Reference: NHTSA Identification Number 04V-531

Safety Recall D48 – Radio Vent Slots

2001-2002 (RS) Dodge Caravan/Grand Caravan and Chrysler Voyager and Town & Country

Figure 1

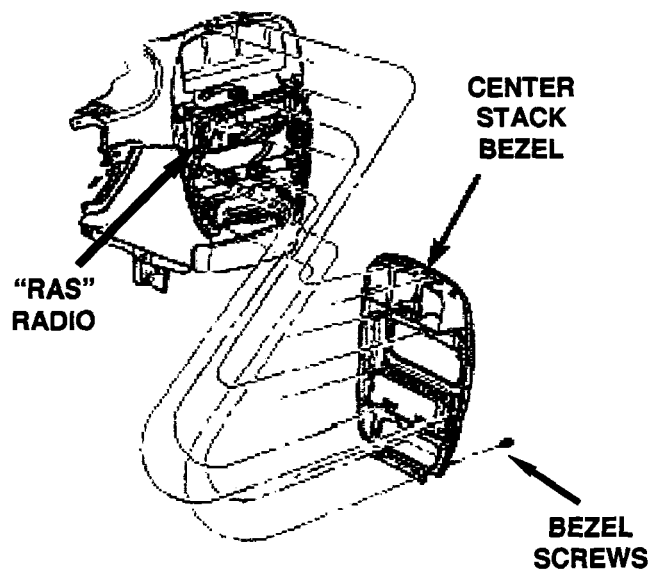
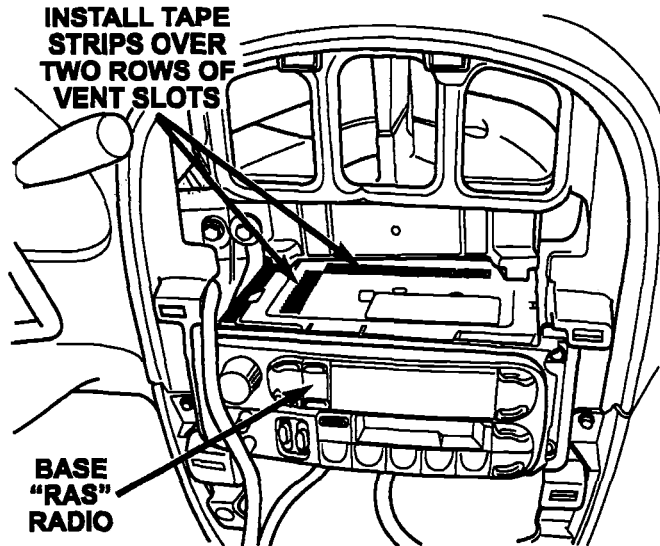
1. Remove the screw access cover from the bottom of the instrument panel center stack bezel (Figure 1).
2. Remove the center bezel attaching screws (Figure 1).
3. Gently pry out on the edge of the instrument panel center bezel using a trim stick (special tool #C-4755 or equivalent). Set the bezel aside leaving the accessory switches connected.
4. Clean the top of the radio assembly with a clean cloth.
